Carolina Pines Avenue Pre-Design Meeting

Project Engagement

Question #2 Part B - If yes, where would you like to see transit bus stops be located?

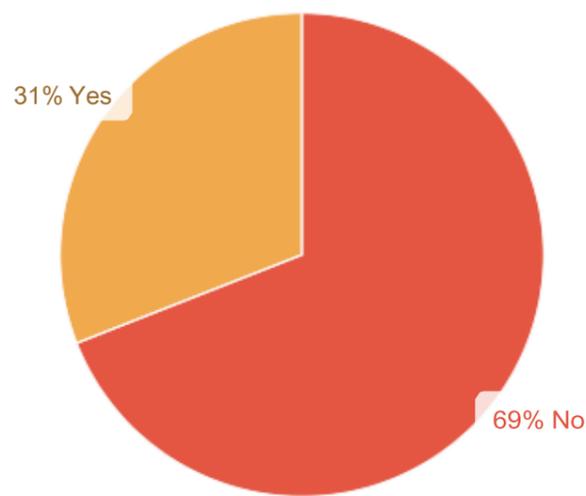
I love the access of the local bus but it's a pain to switch to go downtown. Would be nice if the 7L went to Dix.

They are fine as is except they need sidewalks on Carolina Pines. A bus straight to the city would be better switching busses is not reasonable.

The current locations seem to be getting regular use. I don't see a need to change them.

Spaced appropriately for people with disabilities and direct access to downtown.

If there was a direct route downtown I would use the bus, but at this point we will pay more for Uber/Lyft to avoid hassle of changing lines

I would ride transit if the bus route went from Carolina Pines toward NC State rather than toward downtown or other areas.

I would like to see more stops located near major parks, specifically Umstead State Park and Lake Johnson Park. There are no stops near there, and I've only ever been able to go there via ride sharing or walking several miles from the nearest stop. I think giving us easier access to those locations would encourage more ridership and physical activity at the parks, which is always a great benefit to our city. Please consider this.

Keep bus stop @ the corner of Sardis & C. Pines

About a quarter of the respondents are transit users. Perhaps a greater percentage of area residents would use transit if it was easier to travel to destinations other than downtown. Although beyond the scope of the Carolina Pines Avenue Street Improvements project, these comments will be shared with GoRaleigh Transit.

Service guidelines require a quarter of a mile (1300ft) spacing between each stop. Currently, stops average 800ft+ spacing in between each other along Carolina Pines Avenue. With the improved access/mobility provided for pedestrians and bicycle riders in the project corridor and the low ridership or activity levels at some existing transit stops, the removal/consolidation of stops is being considered along Carolina Pines Avenue. The proposed stops will be shown at the 25% Design Public Meeting.

Question #3 - Do you prefer a traffic signal over a roundabout at Lake Wheeler Road?

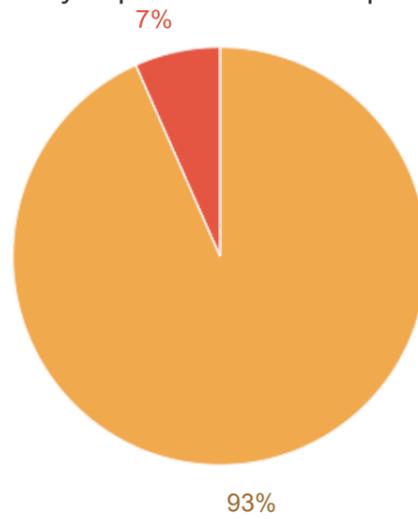
Much prefer a traffic light. There is too much traffic on Lake Wheeler for a roundabout to be appropriate. Ideal would be two lanes leaving Carolina Pines so the right turning traffic can go around the waiting left turn traffic (this would be an improvement, regardless). This light could be timed with the light at Sierra, and hopefully 40, so the traffic wouldn't be too disrupted (it does us no good to make Lake Wheeler back up worse than it already does). This would also help people turning off Lawrence in heavy traffic. This is exactly the worst kind of intersection for a roundabout.

A simple, properly timed light with a proper turn lane from Carolina Pines would be effective.

What happens when traffic down Lake Wheeler backs up past it to 40?

If the roundabout is designed with proper deflection angles, to adequately slow traffic, yes

I would prefer the roundabout option. If the multi-use path option is considered, please consider continuing the multi-use path around the perimeter of the roundabout so cyclists do not have to enter the roundabout.

Traffic circles are generally the better method if you have the room/right-of-way, which in this case they do not. If the property owners are willing to play nice for the good of the rest of us, the roundabout should be the way to go here. There are enough circles in the area that drivers should be used to them by now.

Unless roundabout calms traffic than a signal. Also, the volume of traffic during peak times may overload a roundabout.

Approximately one-third of the respondents prefer a traffic signal over a roundabout (RAB). Many respondents would support a RAB at the Lake Wheeler Road/Carolina Pines Avenue intersection if the RAB would adequately serve the traffic demand at peak times. Traffic volumes were collected by the City of Raleigh during the morning (AM) and afternoon (PM) peak hours of travel. The traffic volumes were used in an analysis to determine traffic operations at project intersections.

Results of the analysis reveal that the Carolina Pines Avenue westbound (WB) approach to Lake Wheeler Road is failing in the AM and PM peak hours. Two methods of addressing the failing intersection are (1) install a traffic signal and (2) construct a roundabout. Based on the traffic analysis, both methods would improve the traffic operations to an acceptable level during the AM and PM peak hours of travel. The consideration of a roundabout at this location is currently being reviewed by NCDOT staff.

For comments concerning routing cyclists through the RABs, please see additional responses to questions below.

Question #4 -Do you prefer a multi-use path over bike lanes?

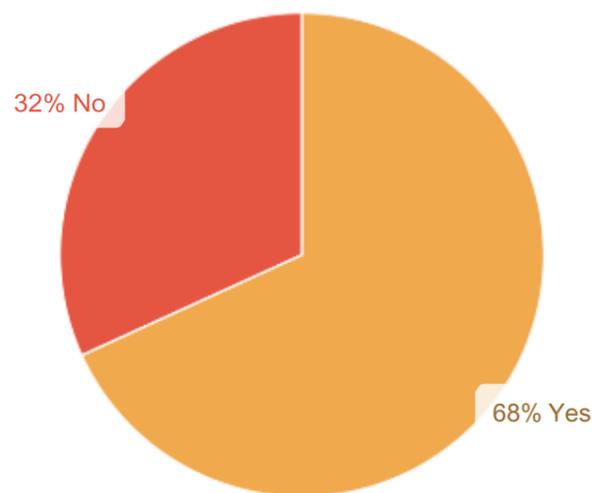
Why not multi-use paths on both sides or a larger multi-use path? 10 feet isn't that wide for bike & pedestrian traffic

The 4.5-foot painted bike lanes in alternative 1 are wholly inadequate on any road with a limit of over 25mph. A MUP is better, but consider one on both sides of the street or at least an 8' sidewalk.

If the multi-use path option is chosen and is used to accommodate 2-way bicycle traffic and pedestrians, the path should be slightly wider, preferably 12-14'.

having a multi-use path is better for runners and cyclists to stay safely out of the road. Bike lanes are most needed on Lake Wheeler.

An overwhelming majority of the respondents prefer a multi-use path (MUP) over a designated bicycle lane for reasons including, overall less impervious surface, requires less right-of-way, separation from vehicular traffic, and is considered safer. The City of Raleigh's Bicycle and Pedestrian Advisory Committee (BPAC) also prefers that bicycle facilities are separated from the travel lanes. Based on citizen input received following the Pre-Design Public Meeting and the comments/recommendations from the BPAC, the project will be designed with the MUP on the south side of Carolina Pines Avenue and sidewalk on the north side.

RABs will be designed with the MUP continuing around the RAB and behind the curb and gutter so that cyclists will not have to enter the roundabout.
